Hope Village

1215 3rd Street NW

**Traffic Circulation Layout**

The TCL submittal received 05-11-2020 is approved for Building Permit with. A copy of the stamped and signed plan will be needed for each of the building permit plans. Please keep the original to be used for certification of the site for final C.O. for Transportation.

SHEET TCL

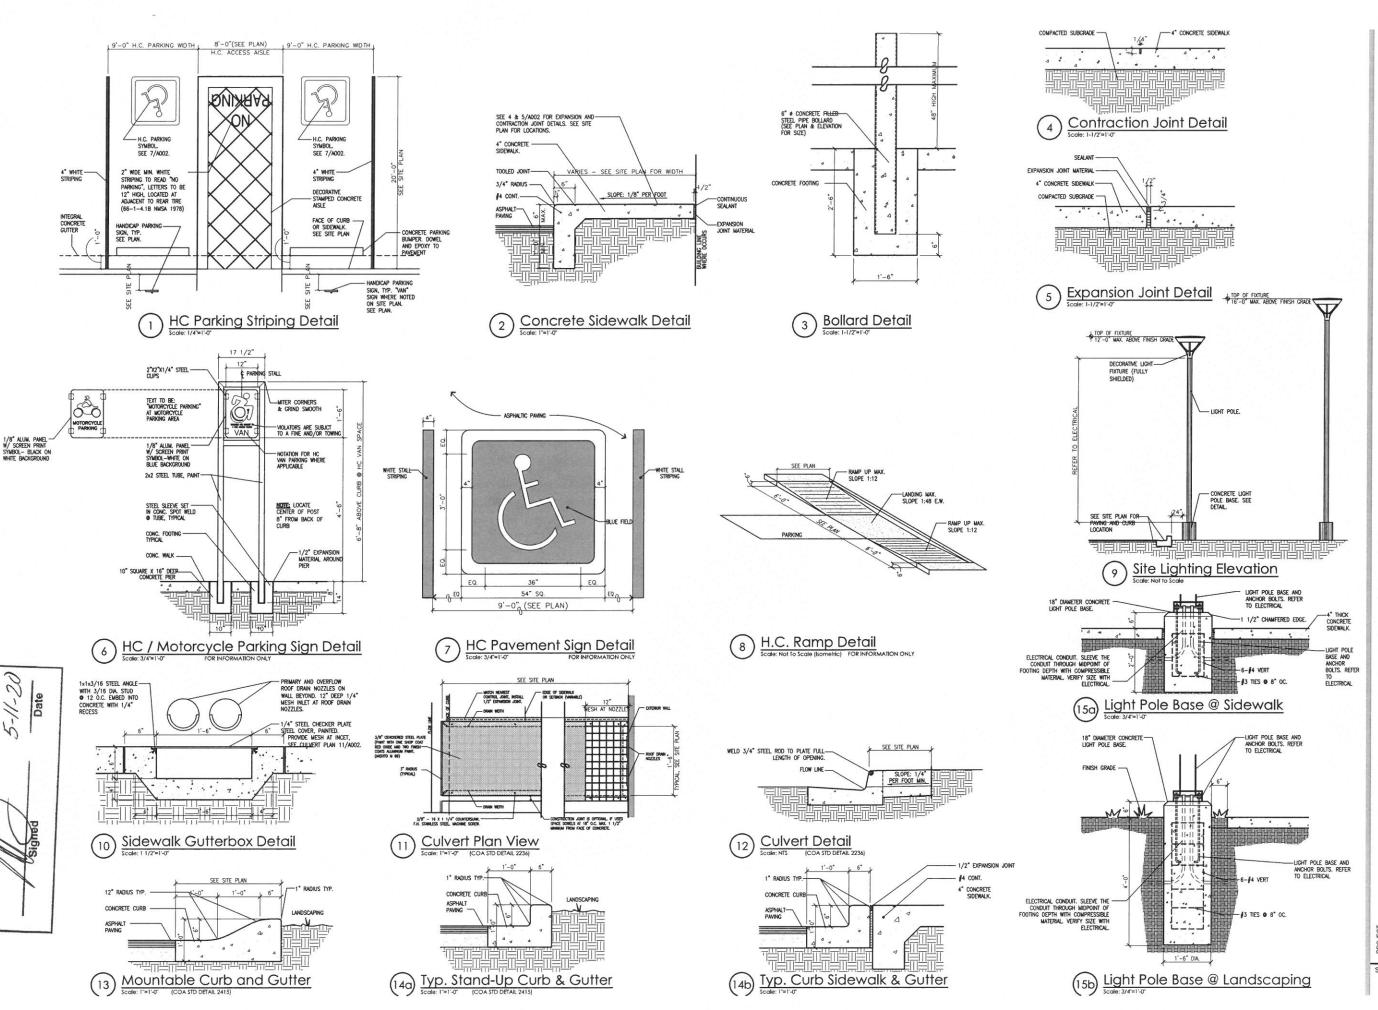
When the site construction is completed and an inspection for Certificate of Occupancy (C.O.) is requested, use the original City stamped approved TCL for certification. Redline any minor changes and adjustments that were made in the field. A NM registered architect or engineer must stamp, sign, and date the certification TCL along with indicating that the development was built in "substantial compliance" with the TCL. Submit this certification, the TCL, and a completed <u>Drainage and Transportation Information Sheet</u> to front counter personnel for log in and evaluation by Transportation.
